XRAY NT1

2009 SPEC CONVERSION SET SUPPLEMENTARY SHEET

#336110 GRAPHITE RADIO PLATE - V2

DETAIL

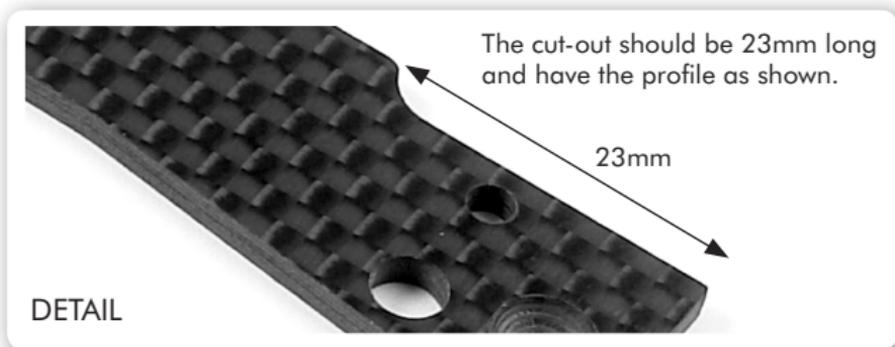
The NT1 - 2009 conversion set does not include the new #336110 Graphite Radio Plate - V2 as only a small modification is required. The radio plate was updated to fit the new updated belt tensioner and belt tensioner mount. Follow these steps to make the modification on your standard graphite radio plate:

Trim the corner of the radio plate as shown in the picture.

The cut-out should be 23mm long and have the profile as shown.
